DRAWINGS AND DESCRIPTION OF PROPOSED CHANGES
UPPER FLOORS - THIRTY-SEVENTH FLOOR
PROPOSED

TOTTENHAM HALE CENTRE
ISLAND SITES
drawing title / location
PROPOSED L37 FLOOR PLAN

3.0 DRAWINGS AND DESCRIPTION OF PROPOSED CHANGES

3.4 BUILDING 1 UPPER FLOORS - THIRTY-SEVENTH FLOOR

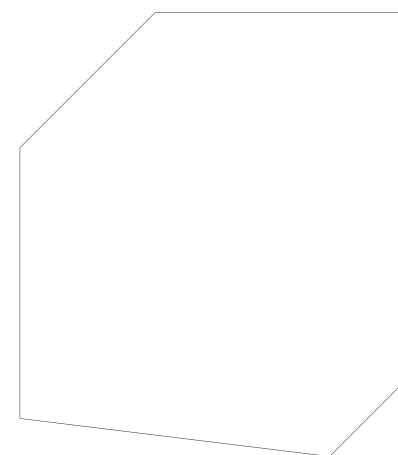
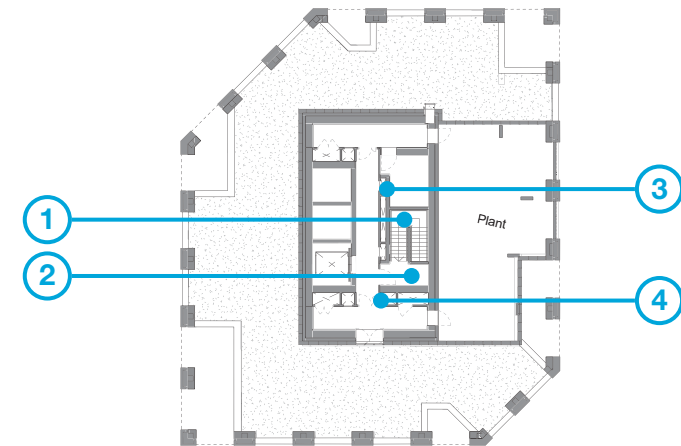
1. A second fire escape stair has been added between ground floor to upper levels.
2. Due to the addition of the second stair, the position of the access to the stairs has changed to resolve level changes across all floors.
3. Service risers have been relocated within the core following the addition of the second staircase.
4. Additional doors have been added within the communal corridors to comply with the latest fire strategy.

3.4 BUILDING 2 UPPER FLOORS - ROOF

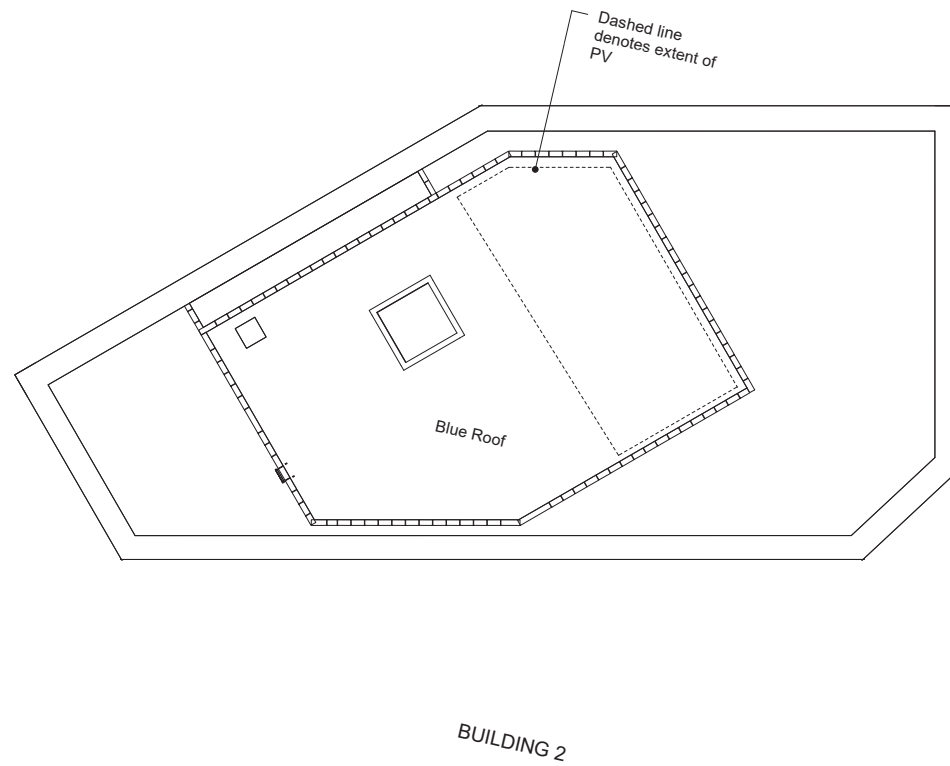
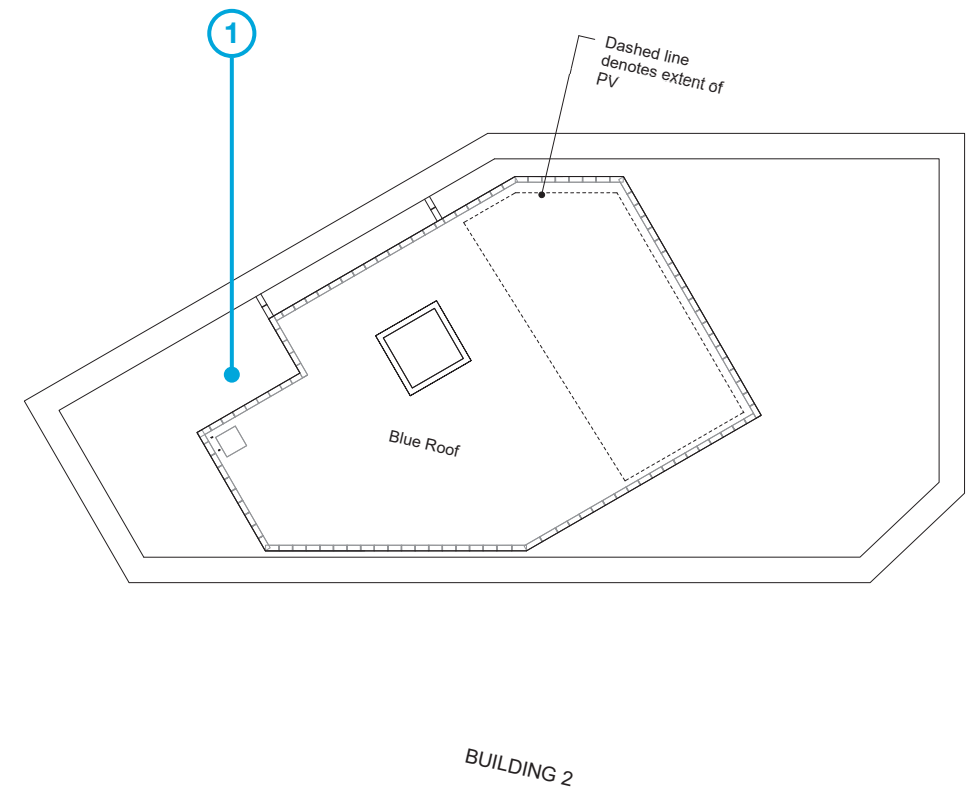
1. Updated roof plan to capture the rotation of the stair on the lower floors.
